| Notice of Allowability | Application No. | Applicant(s) |
| | 10/728,758 | MATSUDA ET AL. |

EXAMINER'S AMENDMENT

Fig. 1

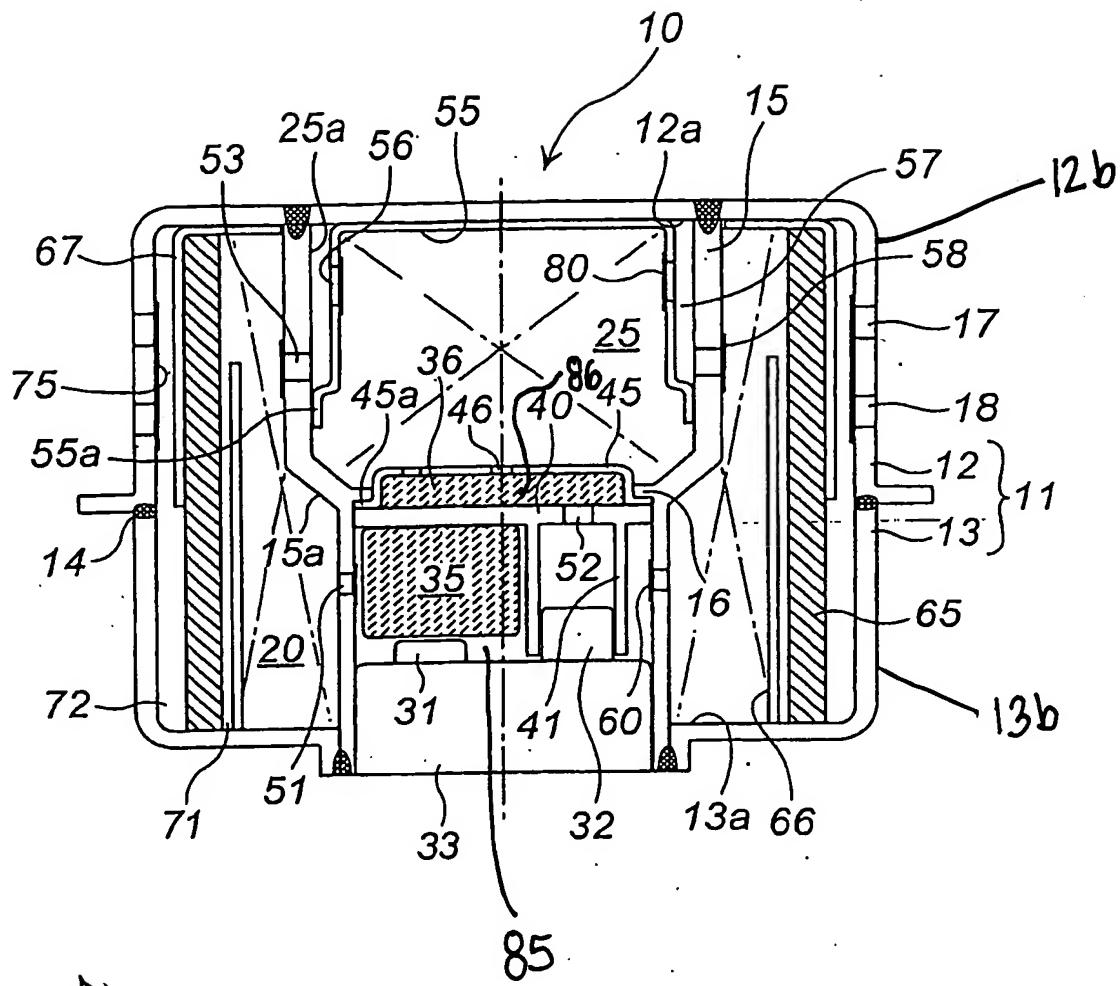
2. The following changes to the drawings have been approved by the examiner: reference characters 85 and 86 have been added to Figure 1 in reference to first and second ignition means chambers, and reference characters 12b and 13b have been added to Figure 1 according to the specification, see the attached marked up copy of Figure 1.

In order to avoid abandonment of the application, applicant must make these above drawing changes.
